**CITY OF LINO LAKES
PLANNING & ZONING BOARD MEETING**

**PLANNING & ZONING BOARD
AGENDA ITEM 6A**

REQUEST: **PUBLIC HEARING** for 601 Apollo Drive Retail
 1. Text Amendment
 2. Site & Building Plan Review

Re: 601 Apollo Drive Retail
Plan Review
021123-000

**LANDSCAPE
 PLAN**

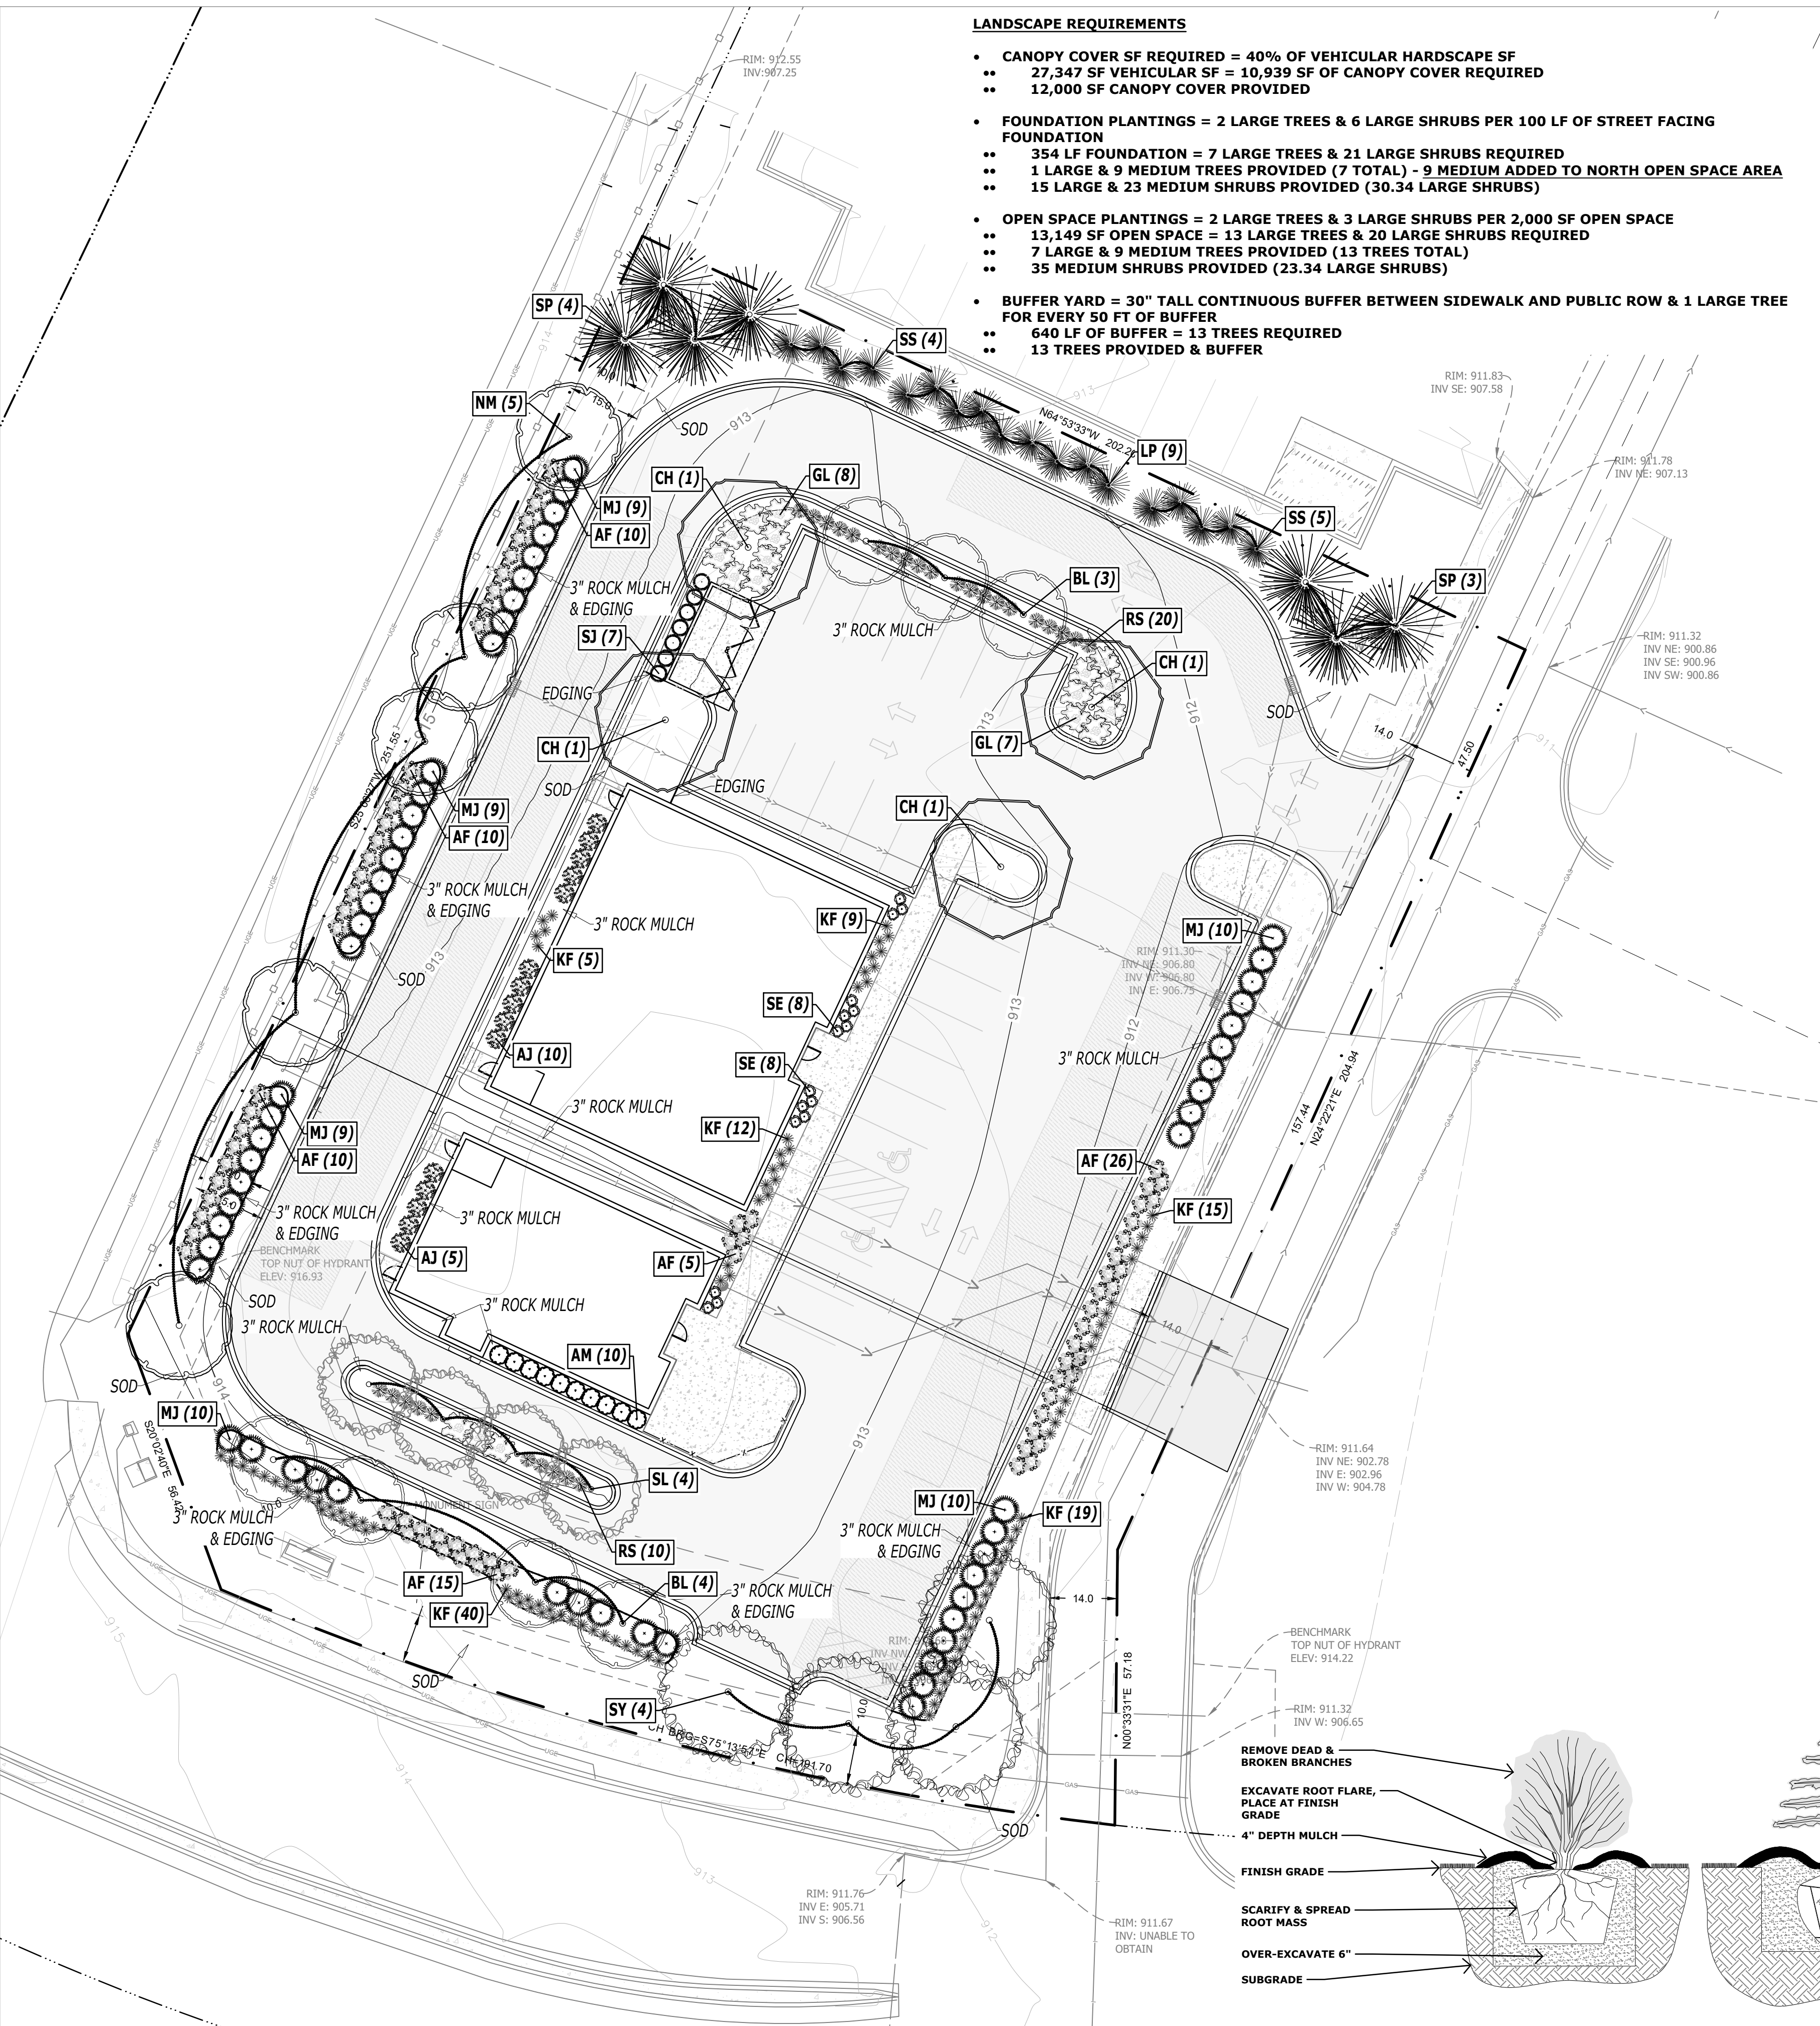
1. (9/7/2022) Applicant to review landscaping near ATM. It does not appear that the ATM is shown on the landscape plans.
2. (9/7/2022) Plants with large canopies shall not be planted adjacent to porous pavement sections.
3. (9/7/2022) No landscape features are allowed to be planted in the pedestrian and bike trail easement. Note – the city requires trees to be at least 10 feet from the edge of trails.

1. Consider a drought and salt tolerant alternative (such as Mn DOT 25-131) to traditional sod for final soil stabilization to minimize water consumption.
2. The trees and shrubs along the western perimeter will have to be shifted closer to the planned curb line. A single row of shrubs should be placed midway between the drainage and utility easement and the pedestrian and bike trail easement. The trees should be planted 7 feet outside of the curb line.
